**Marion County  
Board of County Commissioners**

**PLANNING & ZONING SECTION  
STAFF REPORT**

<b>P&amp;Z Date: 03/31/2025</b>	<b>BCC Date: 04/14/2025</b>
<b>Case Number</b>	250407ZP	
<b>CDP-AR</b>	32444	
<b>Type of Case</b>	<b>PUD Amendment:</b> Request to 1) eliminate vegetative buffering and build only 6'-high privacy fences; 2) add one more lot to PUD; and 3) modify location and type of amenities.	
<b>Owner</b>	Southeast 73 <sup>rd</sup> Avenue, LLC	
<b>Applicant</b>	Tillman and Associates Engineering, LLC	
<b>Street Address/Site Location</b>	16205 SE 73 <sup>rd</sup> Avenue	
<b>Parcel Number(s)</b>	48347-000-00	
<b>Property Size</b>	±39.94 acres	
<b>Future Land Use</b>	Medium Residential (MR)	
<b>Existing Zoning Classification</b>	Planned Unit Development (PUD)	
<b>Overlays Zones/Special Areas</b>	Secondary Springs Protection Zone	
<b>Staff Recommendation</b>	<b>Approval with Conditions</b>	
<b>P&amp;Z Recommendation</b>	<b>Approval with Conditions (On Consent)</b>	
<b>Project Planner</b>	Xinyi Cindy Chen

**Figure 1 – Proposed PUD Concept Plan**

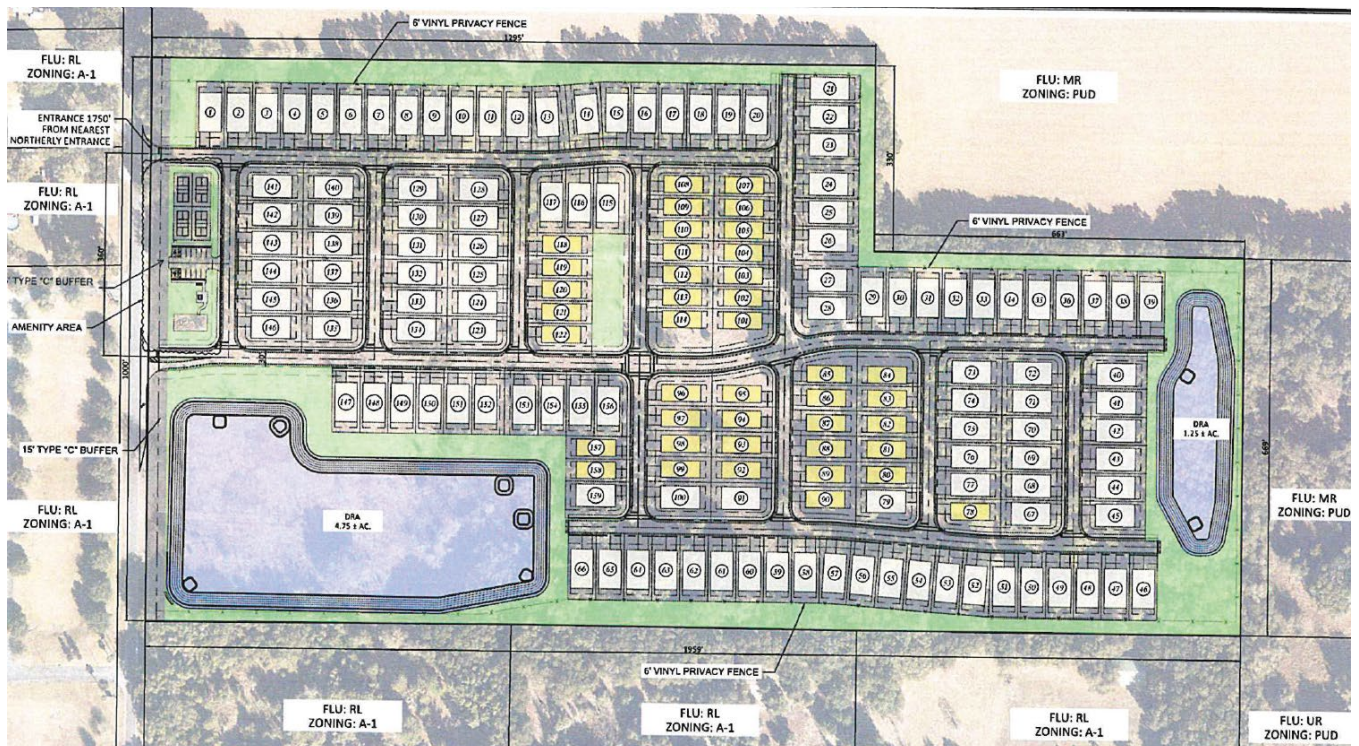
- **The proposed buffer modification does NOT comply with the Land Development Code (LDC) and is NOT supported by Growth Services or Parks and Recreation.** The elimination of vegetative buffering, combined with very limited narrow space for keeping existing trees and vegetation, is likely to result in the decline or loss of the remaining vegetation according to DRC Landscape reviewer. No trees or vegetation is clearly defined to be preserved or relocated in the new proposal. Additionally, staff have concerns regarding the long-term maintenance of these narrow areas between fences and property boundaries. **Therefore, staff recommends that the buffer be implemented in accordance with the previously approved PUD conditions #3 and #4 from case #220919ZP, as outlined below:**

- **Roads and Traffic:** The addition of one residential unit is not expected to significantly impact traffic volumes or roadway capacities. The original Traffic Study, prepared for 158 residential units, estimated approximately 1,537 new daily trips, including 113 AM peak-hour trips and 153 PM peak-hour trips. According to the Development Review Committee (DRC) comments, “the addition of one residential unit, bringing the total to 159 units, will not have a significant impact on trip generation for the site.”

However, DRC Traffic staff also noted that the Traffic Study was completed in 2023 with a projected buildout year of 2027. To date, the developer has not submitted an Offsite Improvement Plan for the required left-turn lane, despite having a proportionate share responsibility of 45%. Additionally, comments regarding driveway alignment from the original PUD application and the associated improvement plan remain unresolved and should be addressed as

part of this PUD amendment. Specifically, the alignment of the southern driveway should be revised as required by the County Engineer, and the northern driveway should be explicitly designated as emergency access only. All previously approved traffic-related conditions and required improvements under case #220919ZP should remain in effect. **Thus, the Traffic**

- Prior to completion and approval of the final PUD Master Plan, an updated Traffic Study reflecting the revised buildout date shall be completed to the satisfaction of the County Engineer and Planning director, adequate provision shall be made for the coordination of the improvements with the PUD.

- An Offsite Improvement Plan shall be submitted, detailing the construction of the proportionate share turn lane, a right-turn lane at the southern driveway, and any other improvements deemed necessary based on the updated Traffic Study.

- The alignment of the southern driveway shall be provided as needed to meet the satisfaction of the County Engineer. The northern driveway shall be designated for emergency access only.

- A 25-foot-wide right-of-way shall be provided along SE 73rd Avenue. A sidewalk or multimodal path shall be developed along SE 73rd Ave, in accordance with the LDC. Sidewalk shall be provided on at least one side of internal roads. The internal roads shall be 50'-wide right-of-way with 5'-wide easements on each side.

1. The PUD shall consist of a total of **39.94** acres with a maximum of **159** residential homes and accompanying accessory amenities consistent with the Marion County Land Development Code, the PUD Application, and PUD Concept Plan (Dated **01/24/2025**; attached).

3. Buffers shall be **provided as approved 220919ZP** and consistent with the LDC.
4. All project-wide walls, fences, and buffers, including all vegetative plantings, shall be installed and maintained in perpetuity consistent with professionally accepted landscape practices, unless & until modified through the appropriate Land Development Code PUD Amendment Process.

8. The location of the northern and southern driveways shall be revised as needed to meet the satisfaction of the Office of the County Engineer. One of the two driveways may need to be converted to emergency access only as determined by the Office of the County Engineer. The need for turn lane(s) at one or both driveways shall be determined by the updated traffic study.

**Figure 4 – Proposed Location, Layout and Types of Amenities**

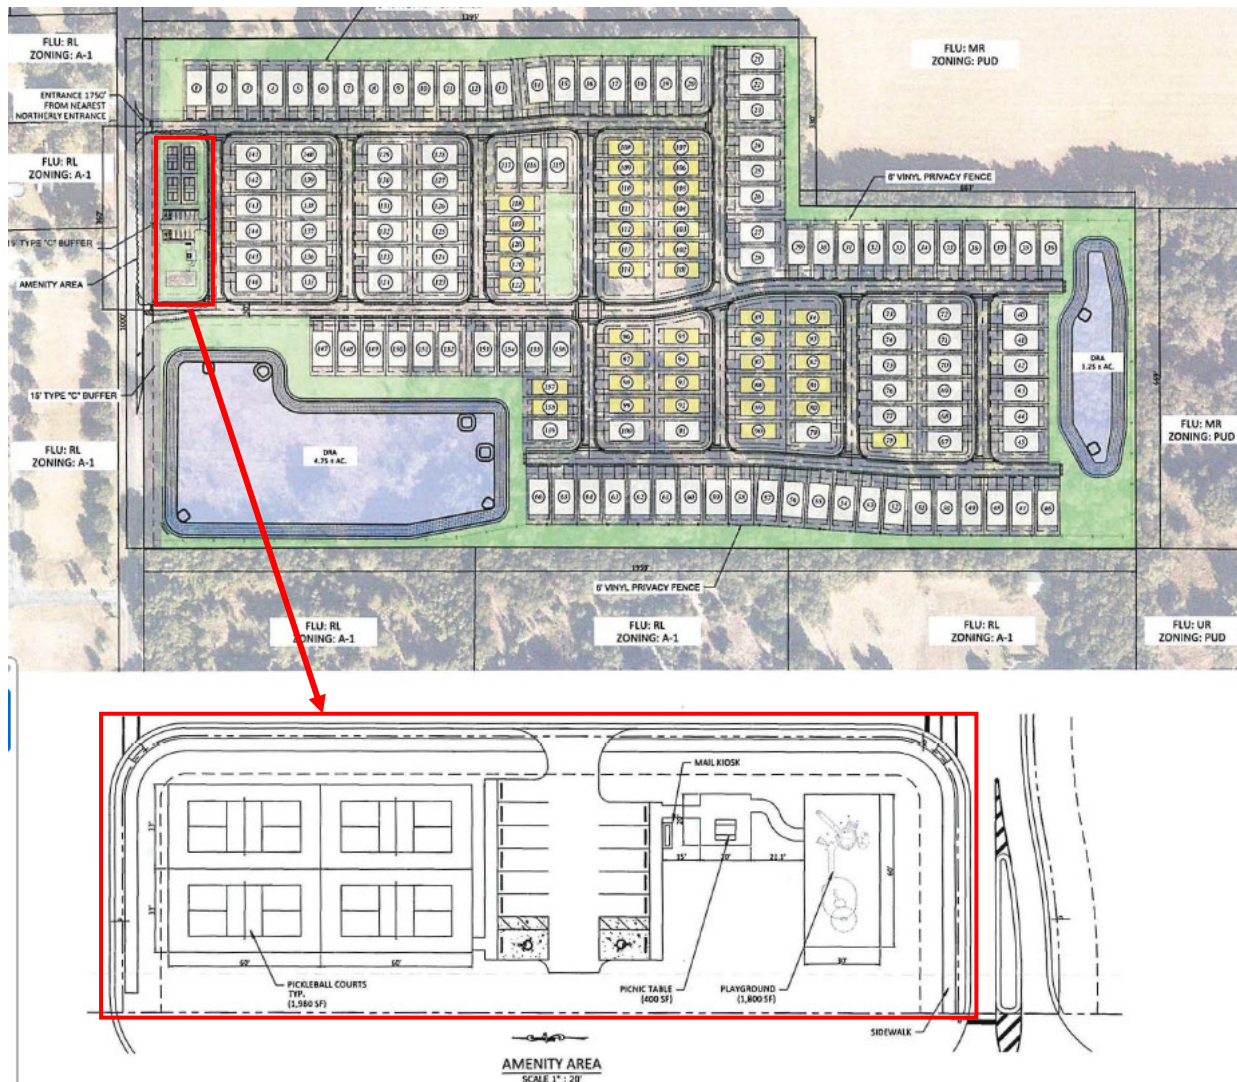
The proposed amendment also seeks to revise the location and type of community amenities. Changes are illustrated in Figure 4 and Concept Plan. The previously approved amenities include a dog park, a community park/walking trail, a

playground, and a clubhouse. The new proposed amenities provide four pickleball courts, a picnic table, and small areas for outside recreation, in replace of previously approved dog park, community park/walking trail, and clubhouse. The playground is kept and its proposed size is 1,800 sqft.

5. The PUD shall provide at least 20% Open Space, consistent with the LDC.
6. Amenities shall include **four pickleball courts, a playground, a picnic table, and small areas for outside recreation, as shown in the PUD Concept Plan (Dated 01/24/2025; attached).**
